GEOTECHNICAL DESIGN AND FOUNDATION PLAN REVIEW MEMO
FOR THE SAN MATEO COUNTY SMART CORRIDOR PROJECT
Dated October 31, 2012

Date: October 31, 2012

Subject: Geotechnical Design and Foundation Plan Review Memo for the San Mateo County Smart Corridor Project

Per your request, we have reviewed additional design plans dated July 19, 2011 for Intelligent Transportation System (ITS) device locations, specifically Extinguishable Message Signs (EMS) and Arterial Dynamic Message Signs (ADMS). Segment 3 of the San Mateo County Smart Corridor project will be located between the cities of Redwood City, Menlo Park, and East Palo Alto, primarily on State Routes 82 and 84, and local arterial streets going to and from, as well as parallel, to US-101. The project is located in San Mateo and Santa Clara Counties. Please refer to figure 1 – Location Map.

FIGURE 3

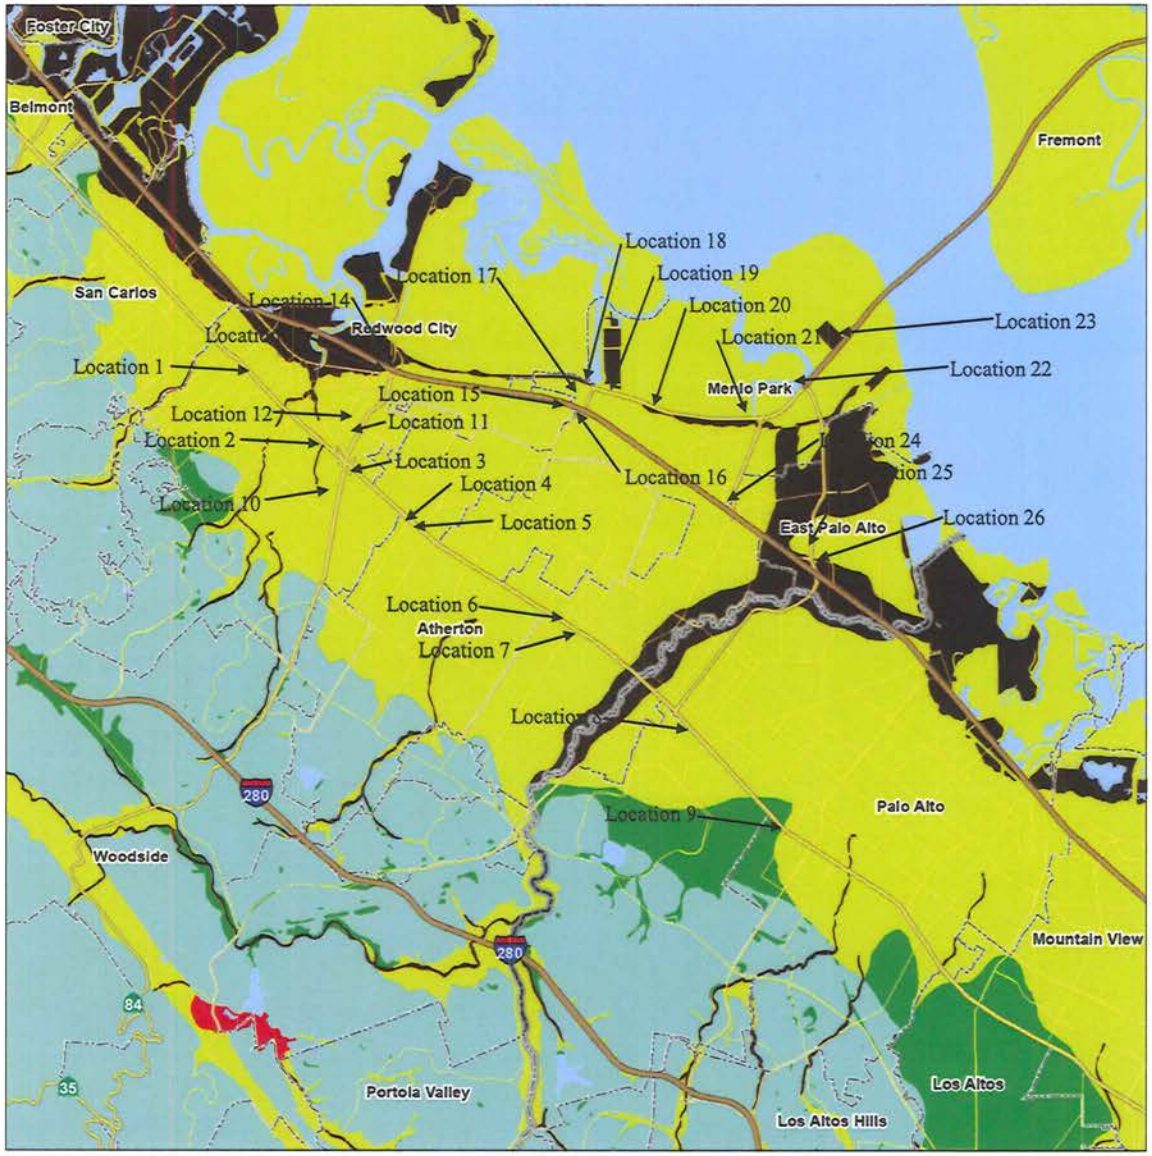
Liquefaction susceptibility is moderate to very high; the susceptibility levels are presented on Figure 3 – Liquefaction Map. Please note that susceptibility is not site specific to each sign location and is a general indication of susceptibility. Based on the available LOTB's, the majority of the anticipated subsurface soils are clayey with medium to high consistency, and sandy soils, which are limited in thickness and relatively compact to dense. Based on this, liquefaction is either a localized zone where

very soft cohesional or loose to compact sands are present. Therefore, the consequence of liquefaction is only ground settlement that may cause tilting and settlement of the proposed foundation rather than the foundation failing.

SES-1

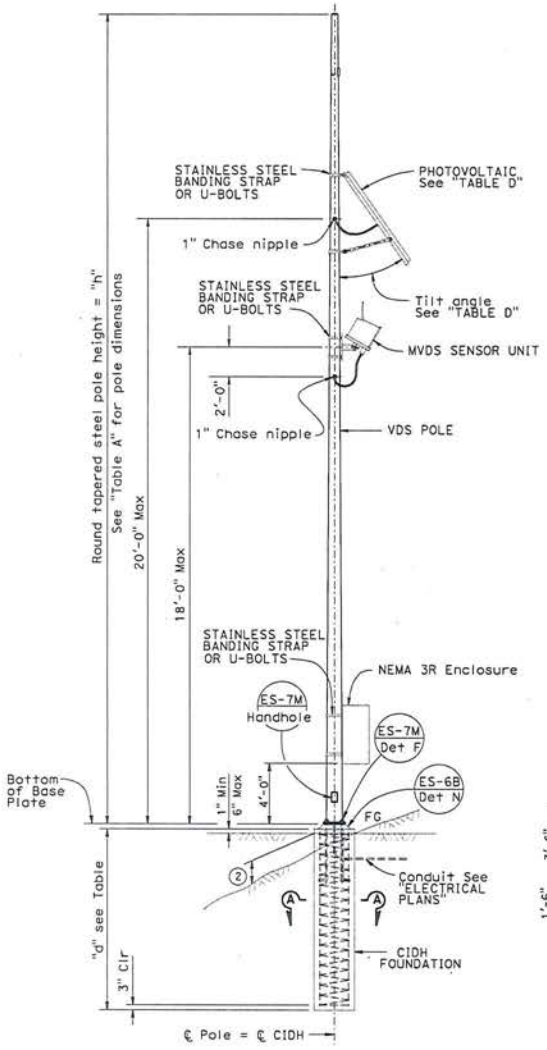
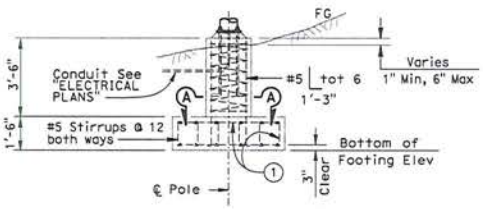
We understand that the MVDS poles are to be founded on 24-inch diameter CIDH piles varying between 8-feet in depth for level ground or 10-feet in depth for sloping ground. Please refer to sheets SES-1 and SES-2, which are attached.

It is our opinion that the site conditions for each foundation type and location will be satisfactory.

SES-3

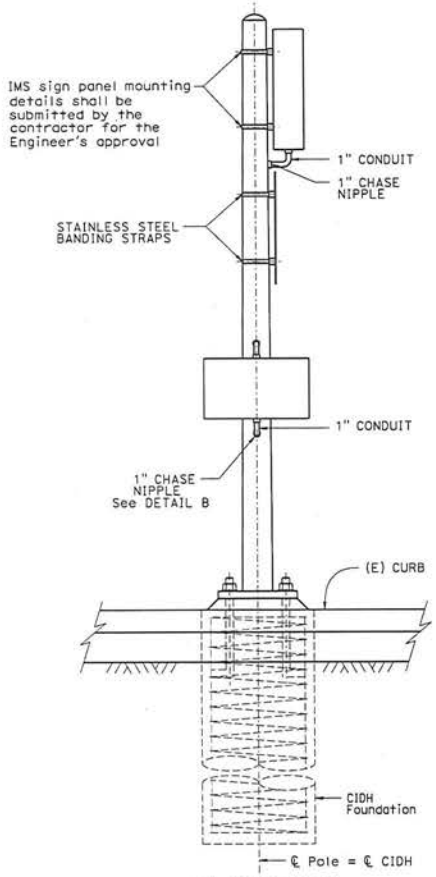
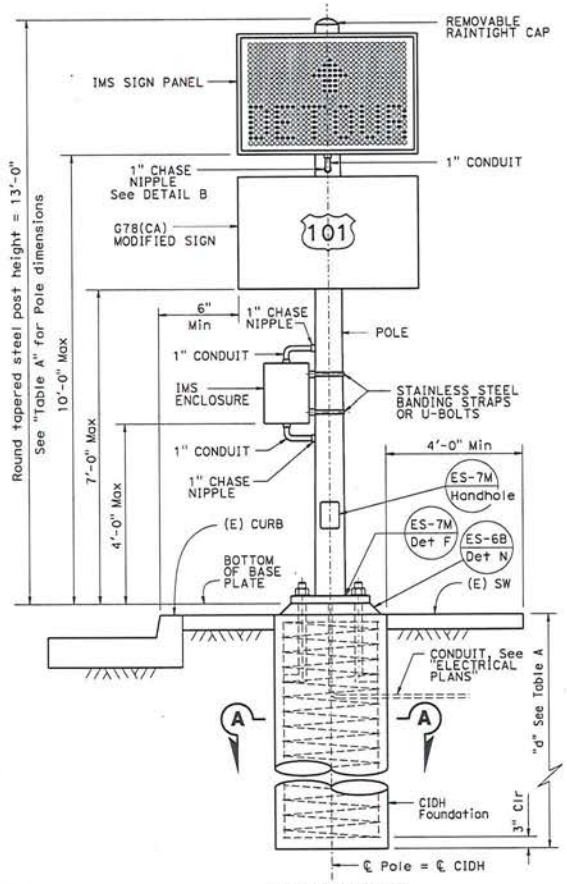
We understand that the EMS signs are to be founded on 24-inch diameter CIDH piles varying between 7-feet in depth for level ground or 9-feet in depth for sloping ground. Please refer to sheet SES-3, which is attached.

2006 STANDARD PLAN ES-16A

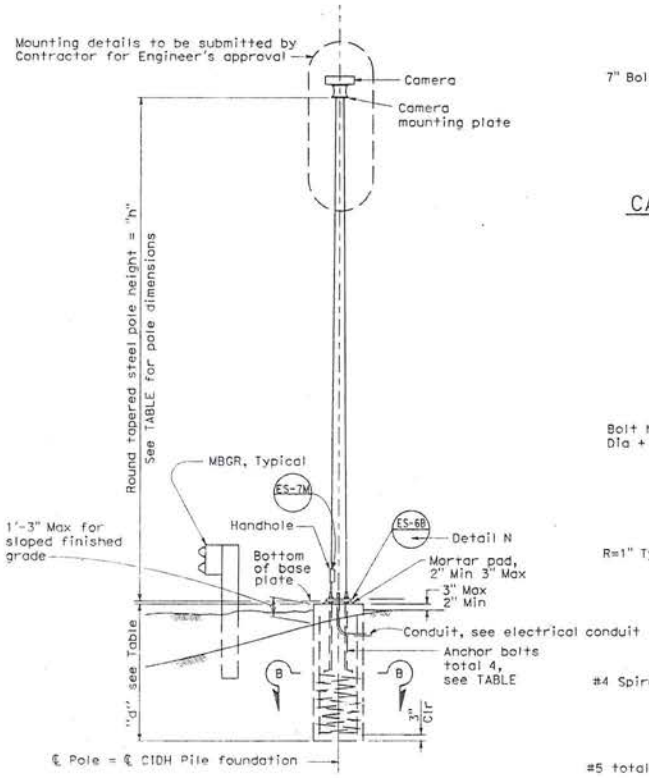
We understand that the CCTV poles are to be founded on 24-inch diameter CIDH piles 6-feet in depth. Please refer to sheet 2006 Standard Plan ES-16A, which is attached.
